Access Compliance Report

Public Rights-of-Way

| Intersection ID: 31480 | Main Street: FLAGLER_LN | Cross Street: SUNMAN_RD | Location: SE |
| ADA ID: 865A0538E73B | Ramp Type: PerpDiag | Initial Pass/Fail: Fail | Overall Compliance: No |

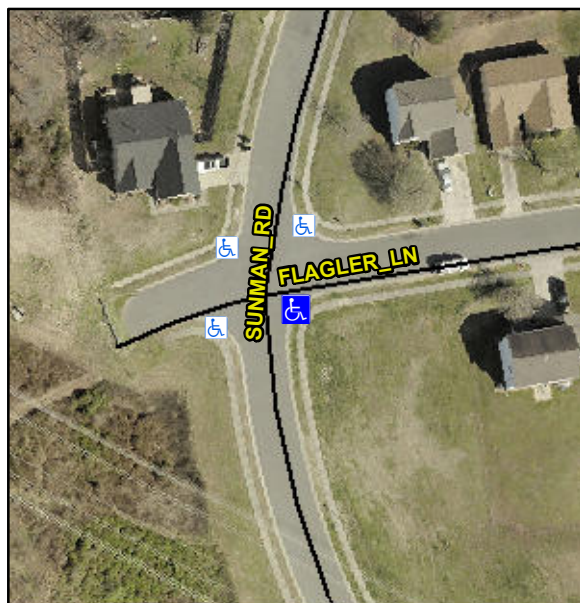
Not Found, R304.5.1, R304.5.3

| Compliance | Description | Data | Compliance | Description | Data |
|------------|-----------------------|------|------------|-----------------------------|------|
| N/A | Ramp Length (in) | 43.5 | Yes | Ramp Slope (%) | 7.3 |
| No | Ramp Width (in) | 39.5 | No | Ramp XSlope (%) | 5.3 |

Remove & Replace Curb Ramp With Two New Directional Ramps or Equivalent.
